Product Change Notification

PRODUCT CHANGE NOTIFICATION

PCN No:	PCN-SM2206
Announcement date	2022-12-14
Scheduled date of change	After 1 st January 2023 (Shipping date from our company)

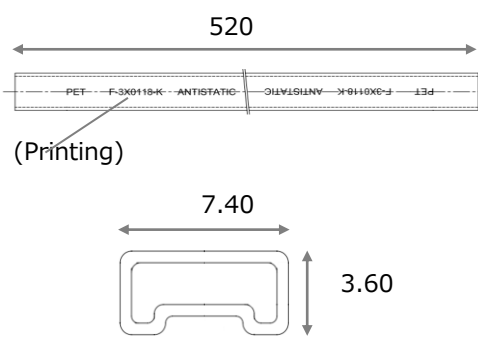
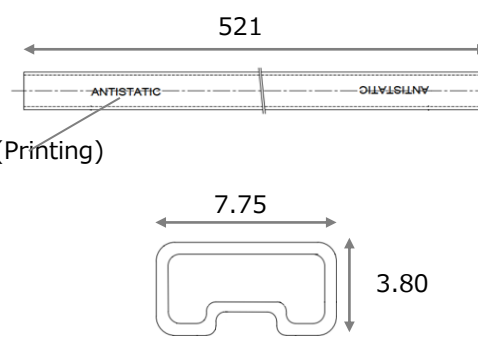
The packing material (ink marking on a tube) of the target products is including mineral oil (MOAH) more than 1wt% which are restricted by France Law for packing material control. Therefore, to keep compliance for this France Law, we would like to change the packing specifications to use new material which is not included mineral oil (MOAH) in a tube (Inkless tube will be newly used).

3. Change of Packing Specifications

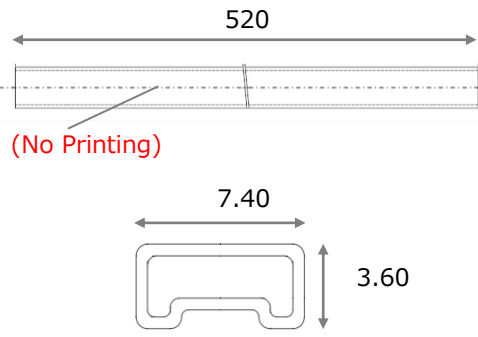
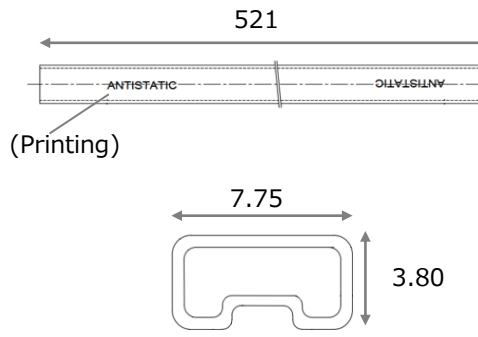
As attached figure, Type-A tube is changed (ink tube is replaced to inkless tube).

For this PCN, Type-B tube is not changed because this type of tube complies to France Law.

□ Changed Tube (Type-A)

Specification	Type-A Tube (Changed)	Type-B Tube (No Changed)
IC Number of storages	95 pcs	95 pcs
External size	 <p>3.60 × 7.40 × 520. mm</p>	 <p>3.80 × 7.75 × 521. mm</p>
Appearance	 <p>(No Printing)</p> <p>(No Printing = Inkless tube)</p>	 <p>ANTISTATIC</p>
